22 April 2026
Ref No: 3646-1012

Re: Response to Additional Information Request
Application No.: DA2025/0523
Proposal: Alterations and additions to Clarence Valley Conservatorium
Property Address: 8 Villiers Street, Grafton NSW 2460
Applicant: GeoLINK Consulting Pty Ltd

CLARENCE VALLEY CONSERVATORIUM ALTERATIONS & ADDITIONS & ADDITIONS

ELEVATIONS & SECTIONS 1

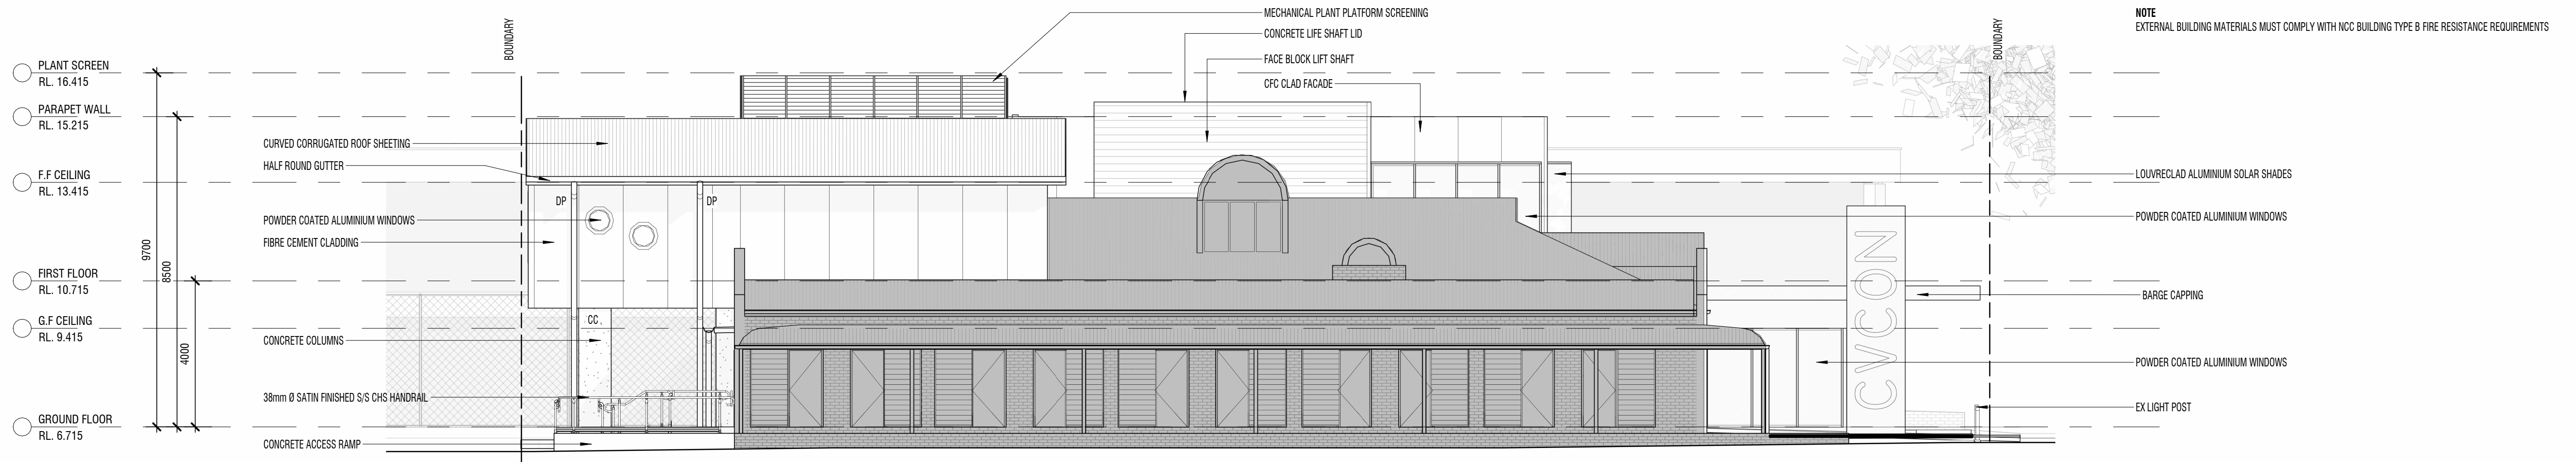
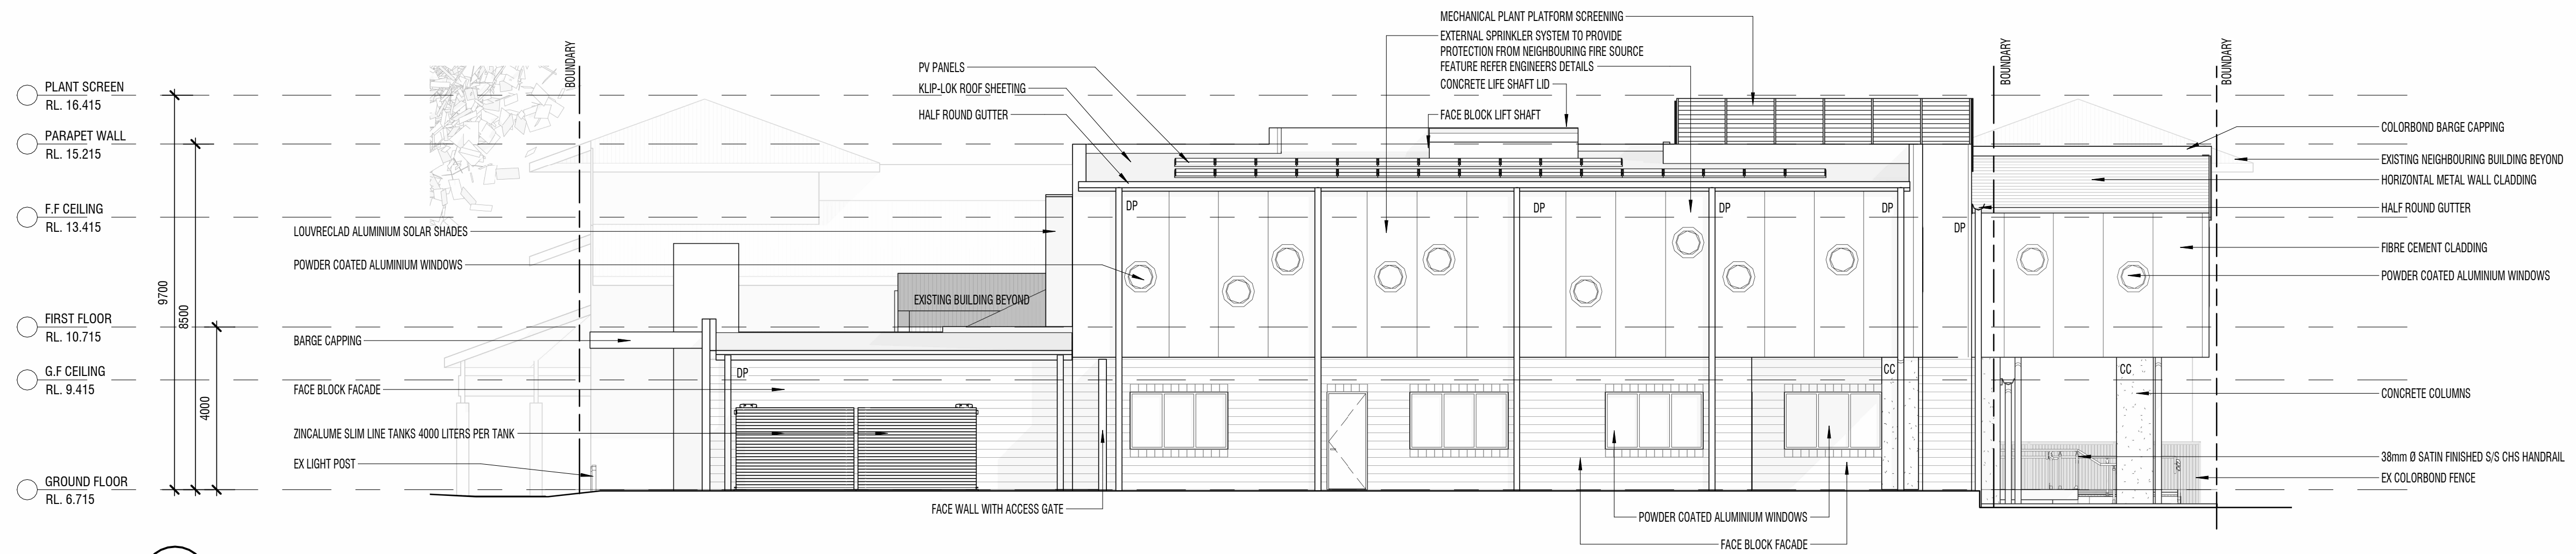
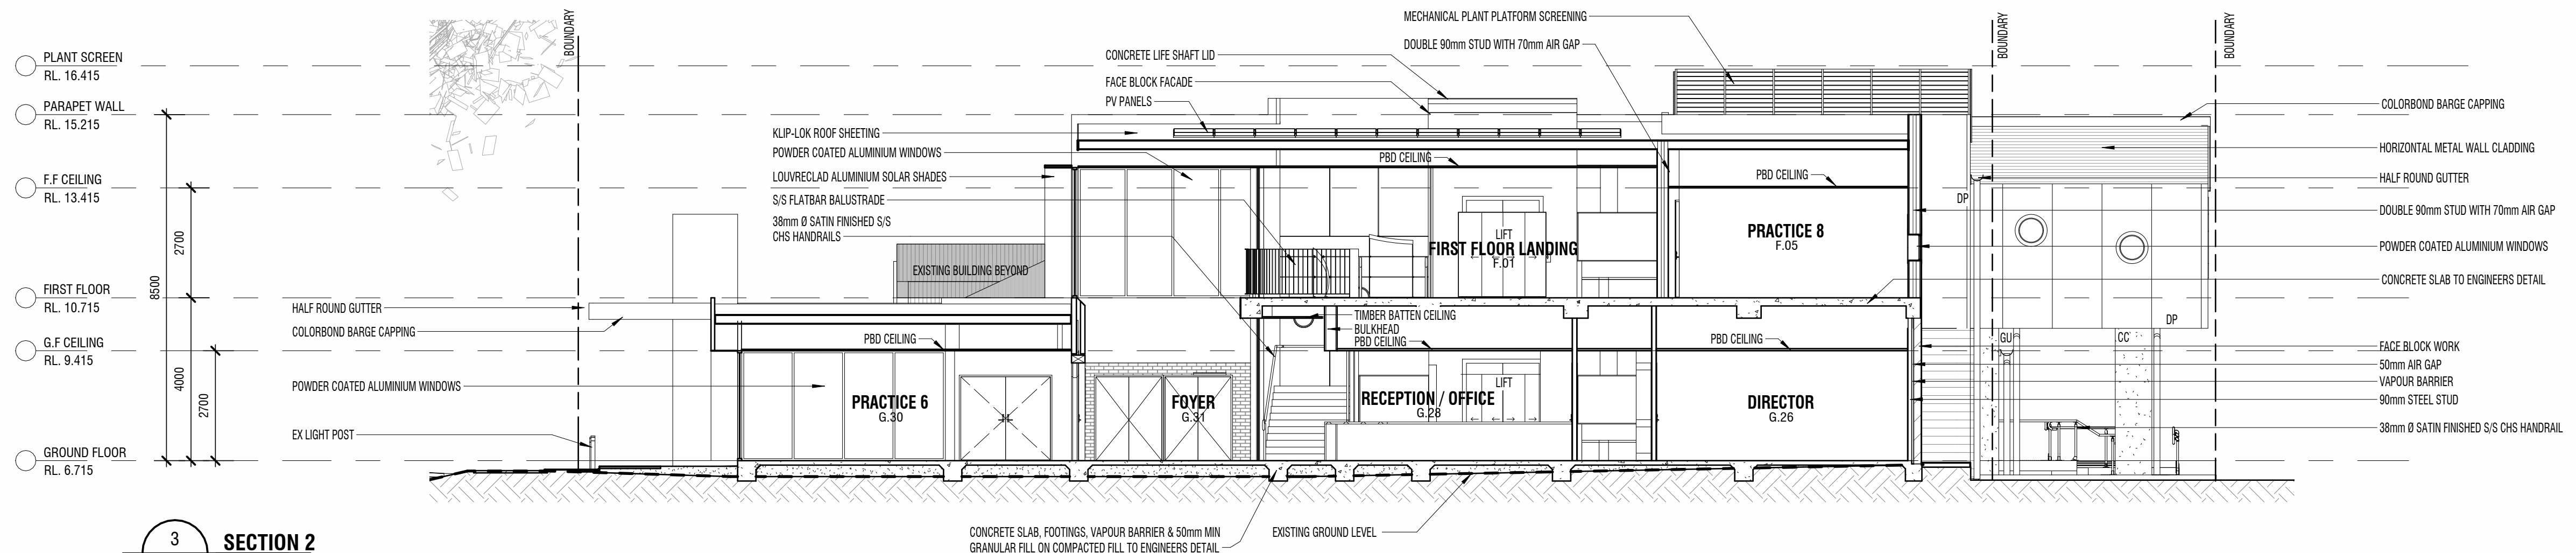
4. Colour and Materials Schedule

The revised architectural plans (DA-2) include a consistent and coordinated palette of external colours and materials that respond to the existing Conservatorium building, the site's civic role, and the surrounding residential context.

The proposed materials and finishes are shown on the Elevations and Sections (Drawing A310) and are summarised below.

Building Element	Proposed Material	Colour/ Finish Intent
Lower-level walls (incl. boundary-facing elements, lift shaft)	Face masonry / face blockwork	Natural or muted mid-tone masonry (grey / off-white spectrum) to provide a robust base
Upper-level walls	Fibre cement cladding	Light neutral tones to visually recess upper storeys
Articulated façade elements	Horizontal metal wall cladding	Muted grey metal finish to add texture and break down mass
Windows & glazed doors	Powder-coated aluminium	Neutral grey or off-white, low-gloss
Solar-shading devices	Aluminium louvres	Matching window finish; visually lightweight
Roofing (incl. curved forms)	Metal roof sheeting (Klip-Lok / corrugated)	Muted grey metal finish to match existing building
Gutters, downpipes, barge capping	Metal (Colorbond or equivalent)	Colour-matched to roof and façade elements
Plant screening	Powder-coated metal screens	Recessive neutral tone to blend with roof forms
